TG13.1 – Roof Park Landscaping and Irrigation

Questions are numbered in the order received. Numbers missing in the sequence either have been answered in a previous response set or will be answered in a future set.

1 GREAT LAWN PLANTERS - SUBSLAB ENLARGEMENT
LI-2638 SCALE: 1/4" = 1'-0"

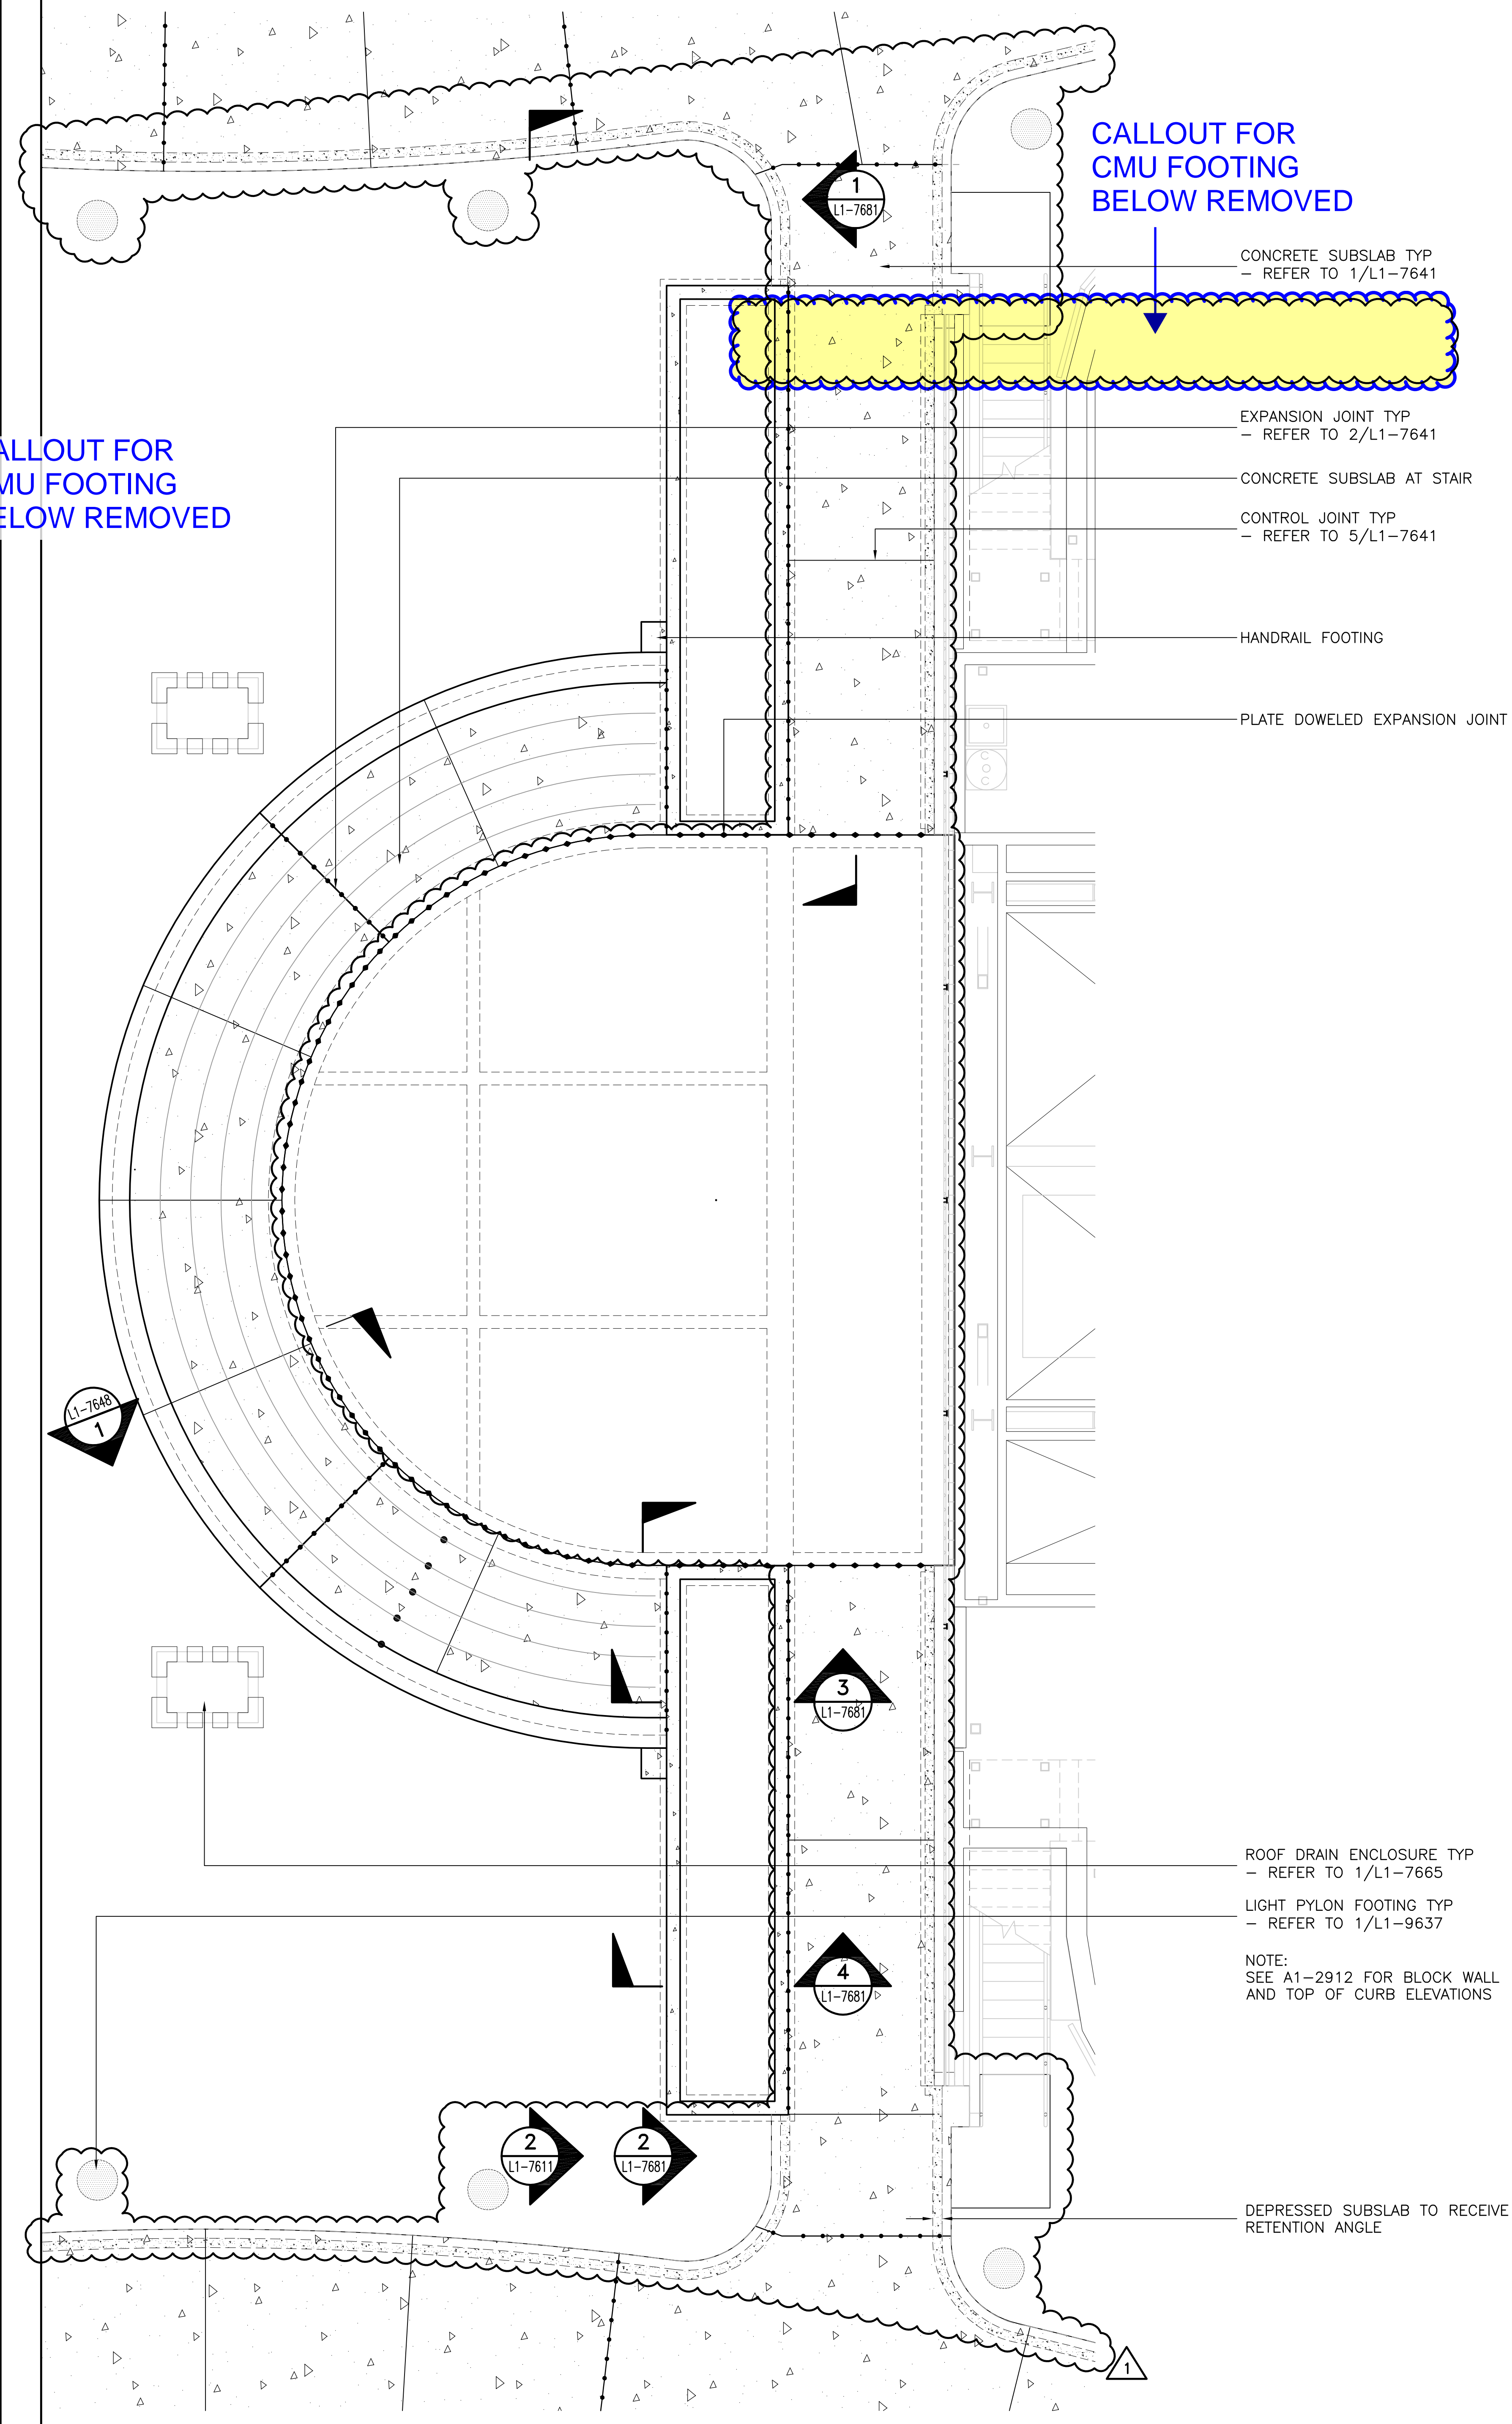
TG13.1-036	4/2/2015	32 15 00 2.1 Materials A and B, L1-2603 and L1-2606		We are requesting clarification as to the depth of Aggregate Mulch Type 1 to be installed at the Elliptical Planter areas shown on Plan Sheets L1-2603 and L1-2606.	See response to Q&A TG13.1-037.
TG13.1-037	4/2/2015	32 15 00 2.1 Materials A and B, L1-2605		We are requesting clarification as to the depth of Aggregate Mulch Type 1 to be installed in Circular Planter Area at Grid Line 15 and between Grid Lines D and F.	Provide 3" depth for Aggregate Mulch Type 1 at these locations.
TG13.1-038	4/2/2015	03 33 12 and 04 22 00, L1-2638 Detail 1		On Sheet L1-2638 there is a callout for "CMU Footing Below" and "CMU Wall Below" at the 4 Great Lawn Planters. In reviewing the referenced Details 2, 3 and 4 on Sheet L1-7681, and Detail 2 on Sheet L1-7682, there are no CMU Footings or CMU Wall shown to be installed at the Great Lawn Planters on Concrete. Please clarify.	Omit reference to "CMU WALL BELOW" and "CMU FOOTING BELOW" as shown on the attached SKLA 391.1. Please refer to 2/L1-7683 for typical detail.
